**RE: San Diego Gas & Electric Company's Response to Notice of Data Inaccuracy –  
NODI\_PAD\_SDGE\_SIS\_20251105\_0853**

### A. Data Inaccuracy 1 – Inaccurate Data Provided on Avian Protection

Figure 2 - Excerpt from SDGE OH 380.1: Wood Crossarm – 6' and 8'

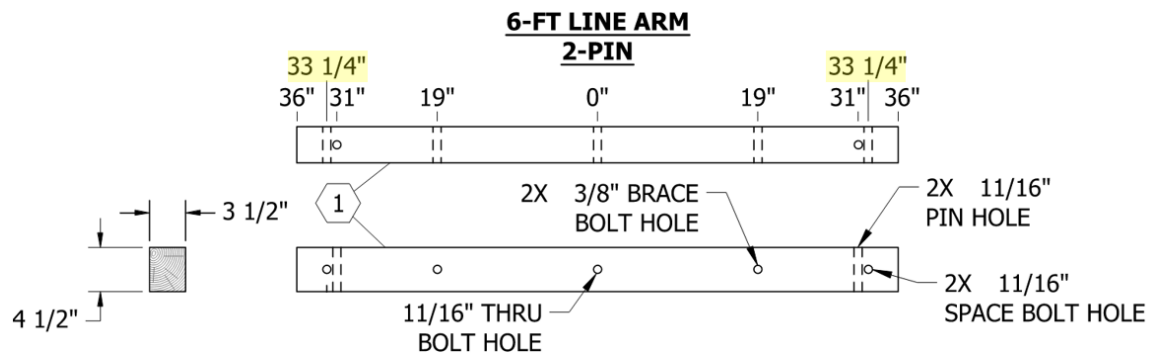
Data Inaccuracy 1. On Pole ID P330064, Grid Hardening ID 530000377023-P330064 at coordinates 32.730586, -116.836448, the inspector observed that SDG&E failed to provide accurate data.

It appears OEIS' conclusion regarding non-compliance is premised on an assumption that avian covers must also be installed on the primary conductors. However, SDG&E's standards require installation of conductor avian covers *only when the distance of uncovered primary line conductor (i.e., phase-to-phase, phase-to-ground, or phase-to-neutral) is less than 60 inches*, per SDG&E's Overhead Construction Standard 1620.2.

Per SDG&E's Overhead Construction Standard 380.1, a 6' wood crossarm possesses conductor spacing of **66.5"** (**Figure 2**) when using the deadend configuration. Per LiDAR data, P330064 possesses a 6' wood crossarm. Thereby, the conductor spacing surpasses the minimum 60" spacing requirement that would otherwise necessitate the installation of conductor avian covers, which is further corroborated by LiDAR data (**Figure 3**). Accordingly, the facility is fully compliant with SDG&E's avian protection standards, and the absence of avian covers on the primary conductors is consistent with both SDG&E's internal specifications and industry guidance, including *Suggested Practices for Avian Protection on Power Lines* published by the Avian Power Line Interaction Committee (APLIC 2006).<sup>2</sup>
